# Service Bulletin No. 375

MODEL <b>E / J Series Coaches</b>	TYPE Field Change Program	SECTION/GROUP 3-Body	DATE Mar. 6, 2012
SUBJECT <b>PARCEL RACK SIDEWALL FASTENERS</b>			
CONDITIONS

Figure 1.

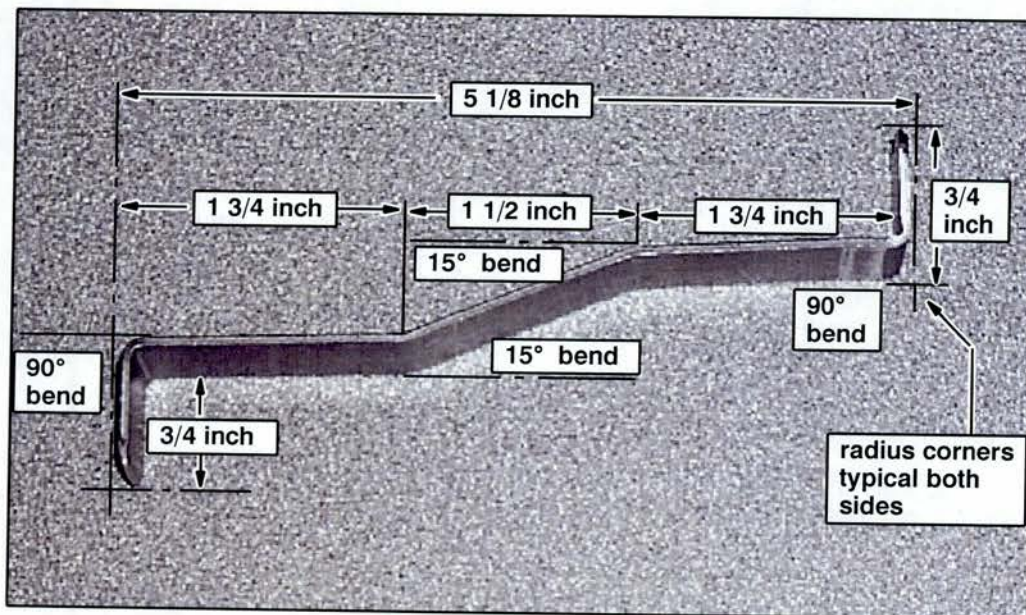
- Fabricate or purchase the tool shown in Figure 1.

*This tool is required in order to properly remove the sidewall mouldings from the parcel rack without incurring any damage to the edge of the moulding.*

*This tool can be manufactured, using 16 gauge steel, following the specs. outlined in Figure 1, or tool can be purchased at SNAP ON / part number A192.*

Figure 2.

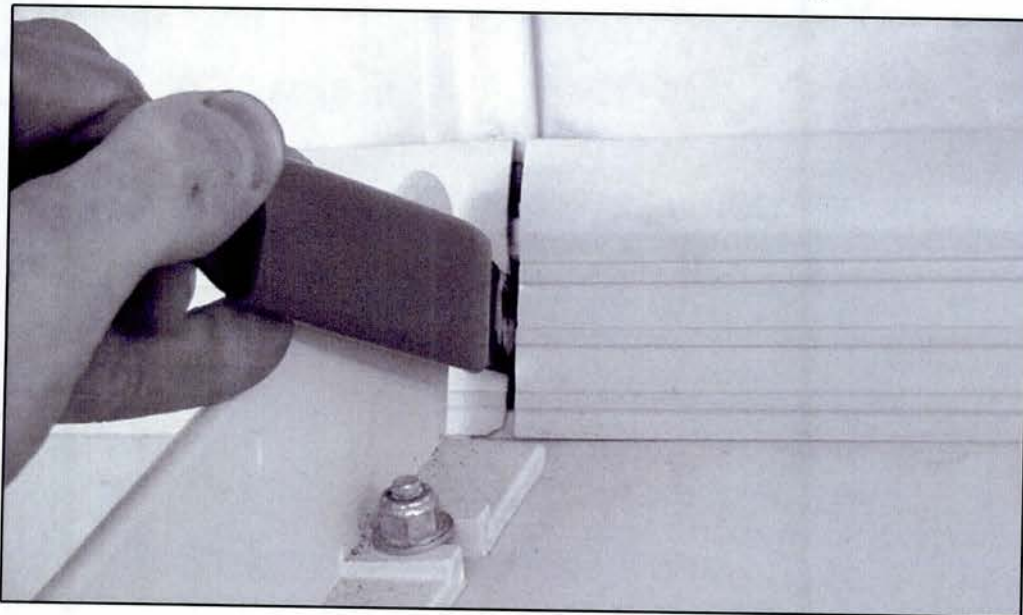
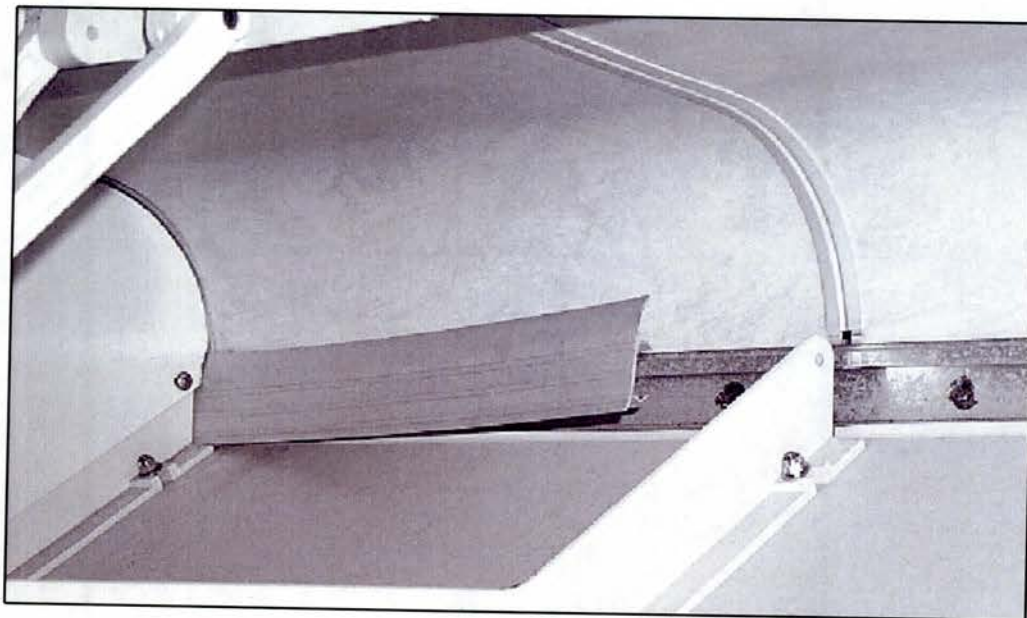
7. Carefully remove and retain the sidewall mouldings using the tool shown in Figure 1.

- 8. Visually check to ensure that there is no gap between the back of the parcel rack aluminum extrusion and the coach structure tube wall.

*Upon visual inspection, if there is a gap use a 7/32 drill bit to drill out the existing fastener and utilize a screw, p/n 19-1-779, to pull the parcel rack aluminum extrusion against the coach tube wall. Proceed to Step 9.*

Figure 4.

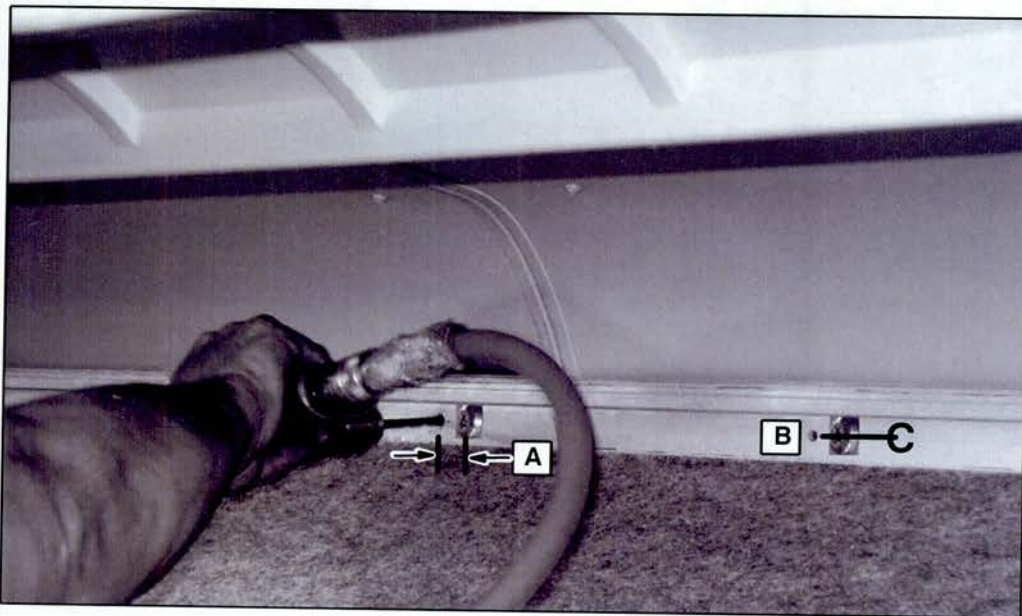
- 9. Using a 9/32 drill bit, drill a hole 1.00 inch to the side of the existing mounting hardware through the aluminum extrusion and the stainless steel tube wall ( refer to Figure 4 ).

ITEM	DESCRIPTION
A	1.0 inch away from the center of the existing mounting hardware
B	Drilled hole should be in line with the center of the existing mounting hardware

- 10. Using rivet, p/n 19-13-255 or 19-13-0402 ( depending on coach VIN / refer to Parts List on Page 1 ), rivet the parcel rack aluminum extrusion to the stainless steel tube wall in the hole drilled in Step 9.
- 11. Repeat Steps 8. to 10. to **all** remaining existing mounting hardware on the parcel rack aluminum extrusion on both the roadside and curbside of the coach.

**Figure 5. Parcel rack / sidewall aluminum extrusion fasteners.**

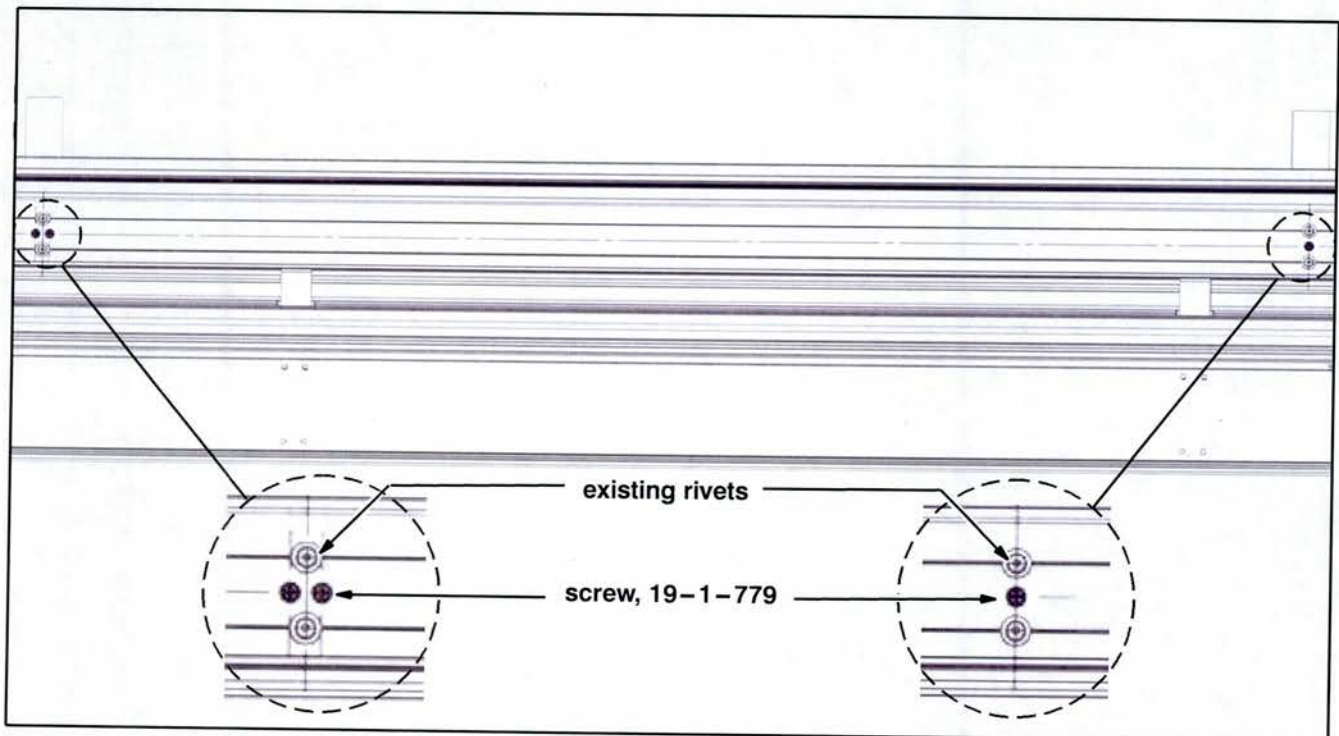
*If screws, p/n 19-1-779, are installed in the parcel rack / sidewall aluminum extrusion on the coach between the range of, and including, VINS 60001 to 61433 ( Figure 5 ), NO further action is required. Re-install the the sidewall mouldings. Close the parcel rack doors.  
Procedure complete.*

*If screws, p/n 19-1-779, are not installed in the parcel rack / sidewall aluminum extrusion on the coach between the range of, and including, VINS 60001 to 61433 ( Figure 5 ), proceed to have the repairs required by MCI FCP 382 performed to install rivets in the roof bows.  
Re-install the sidewall mouldings. Close the parcel rack doors.*
